BROWNS FERRY NUCLEAR PLANT (BFN) - UNITS 1, 2, AND 3 -  
TECHNICAL SPECIFICATIONS (TS) CHANGE TS-418 AND TS-431 -  
EXTENDED POWER UPRATE (EPU) - RESPONSE TO ROUND 16 REQUEST  
FOR ADDITIONAL INFORMATION (RAI) - SRXB-74/86 AND SRXB-87  
THROUGH SRXB-90 (TAC NOS. MD5262, MD5263, AND MD5264)

**TENNESSEE VALLEY AUTHORITY  
BROWNS FERRY NUCLEAR PLANT (BFN)  
UNITS 1, 2 AND 3**

**TECHNICAL SPECIFICATIONS (TS) CHANGES TS-418 AND TS-431  
EXTENDED POWER UPRATE (EPU)**

**RESPONSE TO ROUND 16 REQUEST FOR ADDITIONAL INFORMATION  
SRXB-74/86 AND SRXB-87 THROUGH SRXB-90**

**Figure SRXB-90.3 Bypass Mixture Level  
for .05 FT<sup>2</sup>/PD TOP SF-BATT 102P/105F EPU  
With Bypass Injection of LPCS**

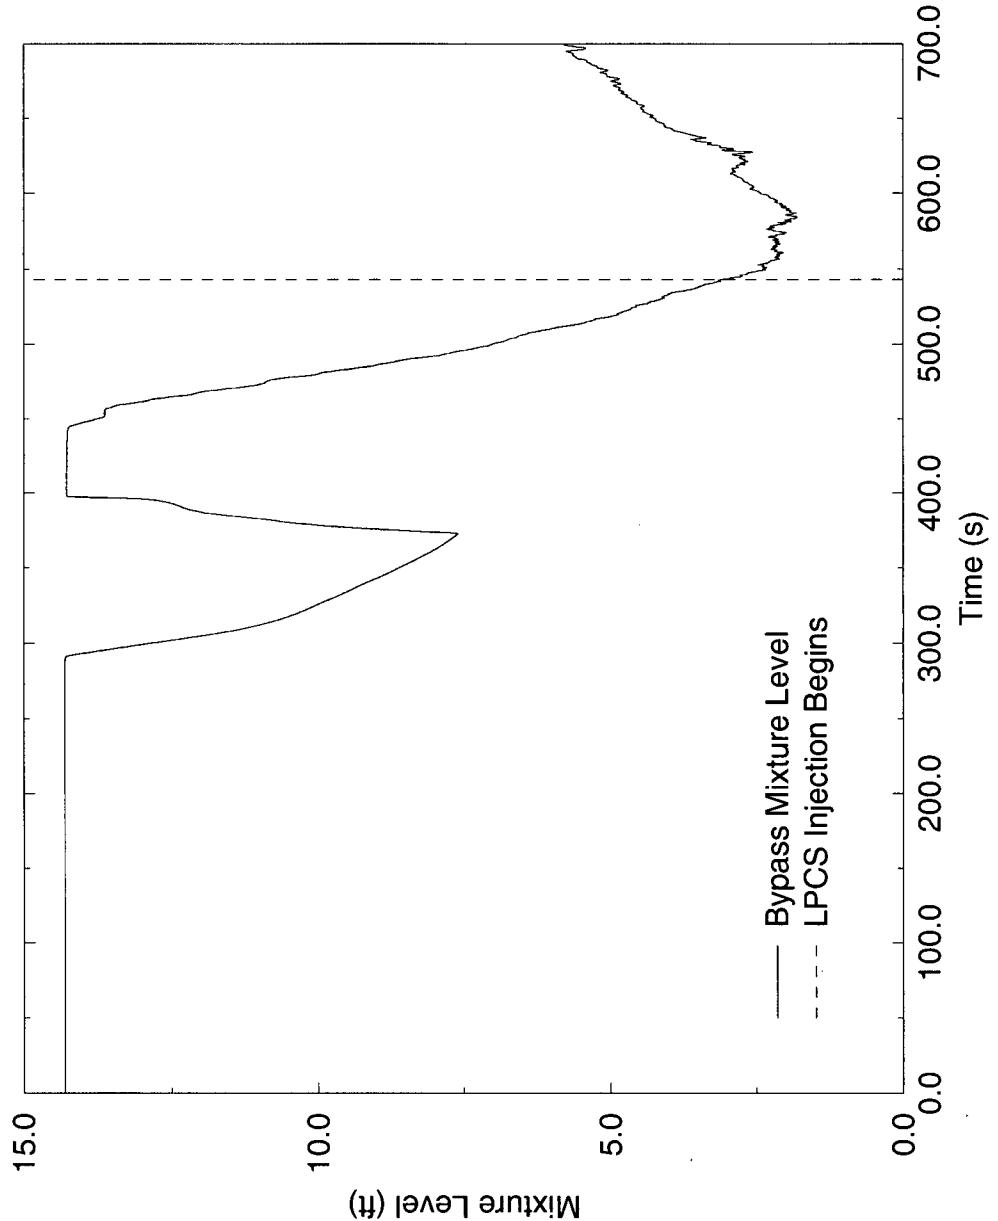
Provide the following information regarding the AREVA LOCA analyses:

- the flow area above the hot bundle exit,
- power of the hot bundle, and
- perform an analysis assuming little or no downflow.

] Therefore, to accommodate the NRC request, the 0.05 ft<sup>2</sup> top-peaked small break LOCA analysis was repeated with the modification that the injection of Low Pressure Core Spray (LPCS) was moved from the upper plenum (node 1 in Figure SRXB-90.2) to the bypass (node 9 in Figure SRXB-90.2). This allowed for the injection of water from the LPCS, which is needed to refill the lower plenum, without LPCS being available for CCFL into the core. Review of the results confirmed there was no top-down cooling from liquid entering the top of the bundle from the upper plenum after the time when LPCS flow starts (the LPCS did not fill the bypass and then flow into the upper plenum). The peak clad temperature (PCT) for this analysis is 1465°F.

Figures SRXB-90.3 through SRXB-90.5 show that the selected modeling is performing as intended. Figure SRXB-90.3 presents the liquid level in the bypass and demonstrates that some of the injected Emergency Core Cooling System water is held up in the bypass. Thus, all of the LPCS injection does not instantaneously drop into the lower plenum. The figure also shows that the bypass does not fill completely prior to reflood. Therefore, no injected LPCS water can spill into the upper plenum to drive downflow of liquid through the core prior to reflood.
